## SERVICE BULLETIN

**APPLICABILITY:** 2018MY Crosstrek

**NUMBER:** 12-266-19

**SUBJECT:** Door Trim Panels- Small Dents Visible in Tricot (Accent) Areas

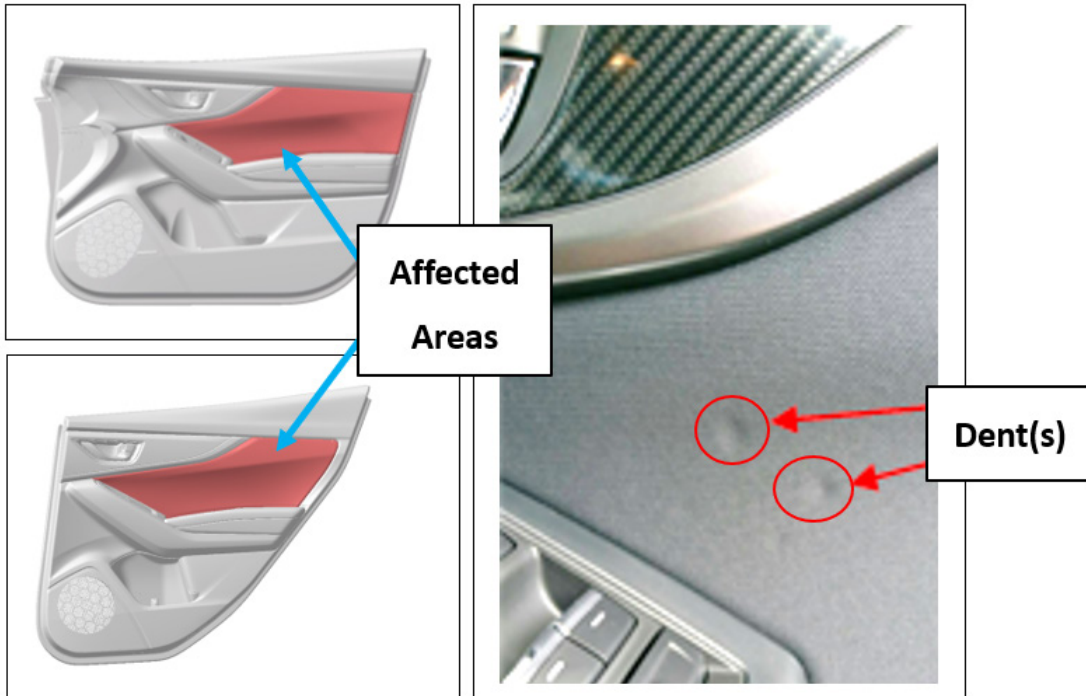
This bulletin announces a change to the interior door trim panels made to address a limited number of concerns regarding small dents appearing in the accent areas as shown in the illustrations below. These dents can occur when the foam layer on the inside of the trim panel covering material is pressed inward and comes in contact with adhesive used during assembly preventing a return to its original condition. An additional barrier has been added during manufacturing to keep the foam layer and adhesive separated.

The new trim panels were incorporated into production starting with VIN **K8235591**.
